**Amendments to the Drawings:**

## **REMARKS**

*Application No.: 10/849,889*  
*Art Unit: 3617*

Fig. 2A

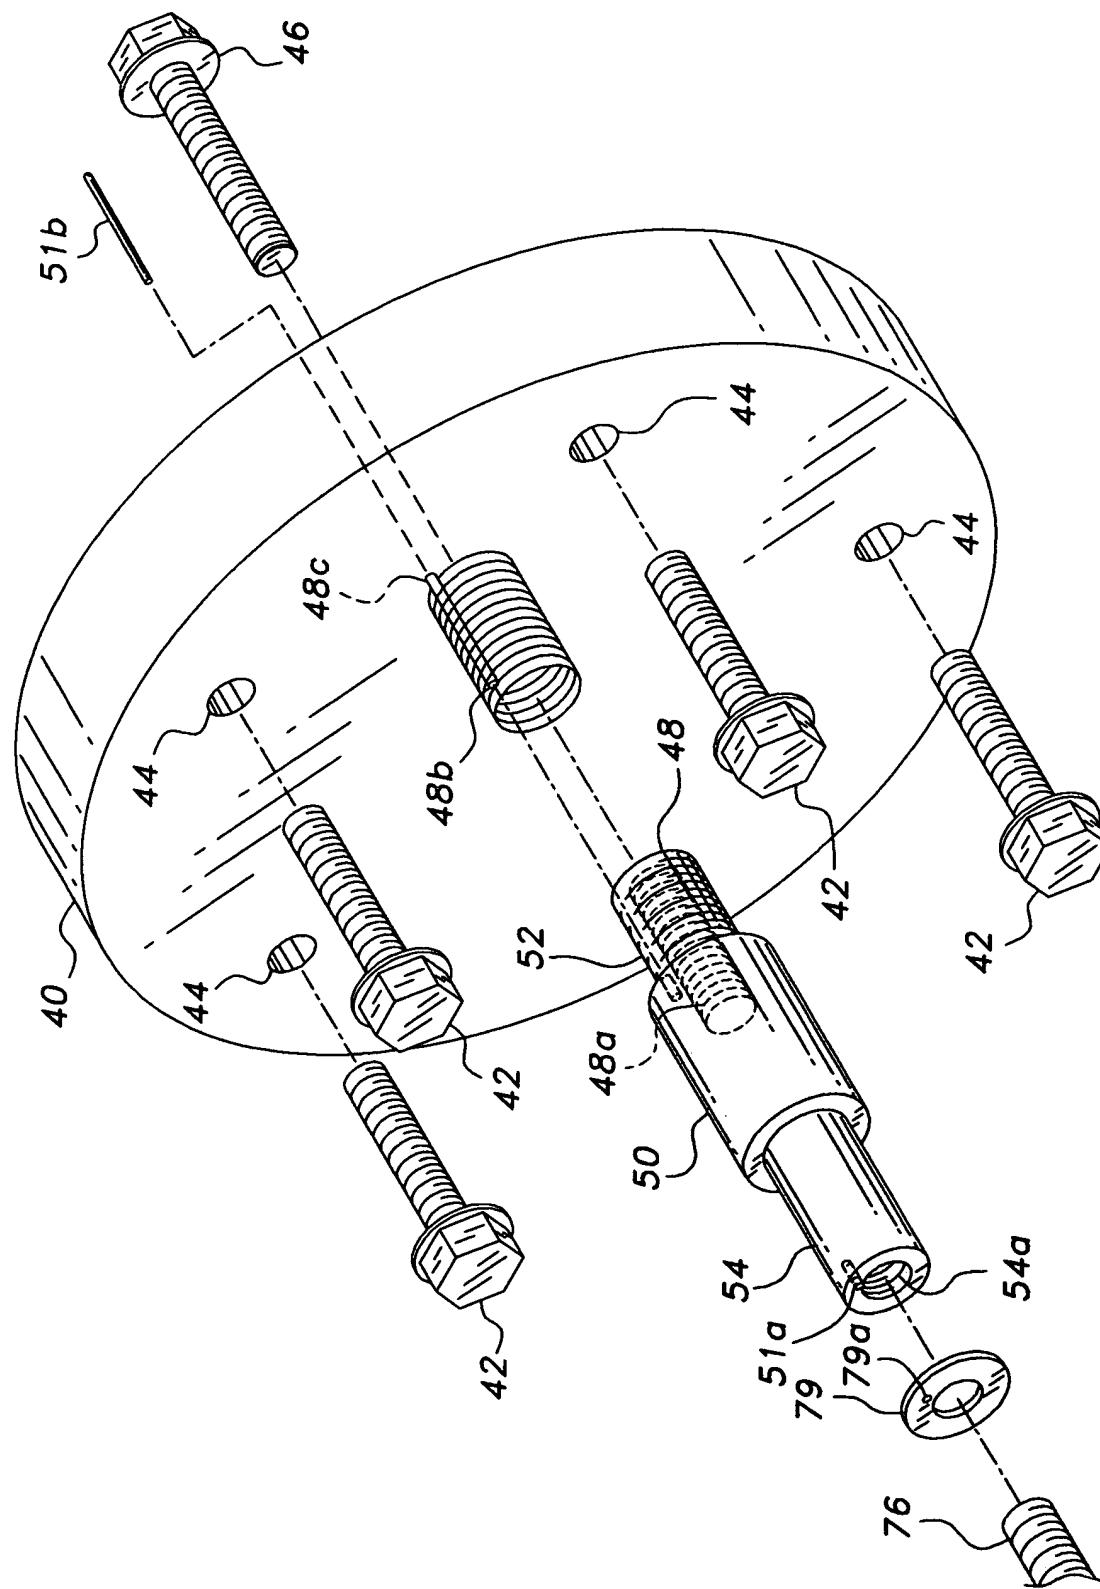
A proposed drawing change is submitted herewith. Proposed changes are shown in red. The attached sheet include changes to Fig. 2A. This sheet, which includes only Fig. 2A, replaces the original sheet including only Fig. 2A. In Fig. 2A, plate **40** including holes **44**, bolts **42** and **46** have been added. Pin **51b** has been exploded to show its pre-assembly position. Reference characters **48a**, **48b**, and **54a** have been added to more clearly show previously indicated threaded surfaces. Reference character **48c** has been added to clearly show an opening for receiving pin **51b**.

In the recent Final Office Action the drawings were objected to under 37 CFR 1.83 (b) as being incomplete. The Examiner held that it was unclear (1) why the external surface of end portion **52** is threaded; (2) how this threaded end could be threaded into the threaded bore in plate **40** since pin **51b** would prevent rotation of shaft **50**; (3) internal threaded bore in end **52** not shown; (4) where pin **51b** is received in plate **40**.

Applicant regrets the lack of clarity in showing these features in the drawings. To this end Fig 2A and the specification have been amended so that these features are clearly illustrated and explained. As shown (1) bore in plate **40** is provided with internal threads **48b** to receive threaded end **52**; (2) pin **51b** is shown exploded from shaft **50**. Pin **51b** is not inserted until after end **52** is threaded into bore plate **40**; the internal threaded bore for end **52** has been designated as **48a**; (4) reference character **48c** indicates an opening (shown in phantom lines) in plate **40** for receiving pin **51b**.
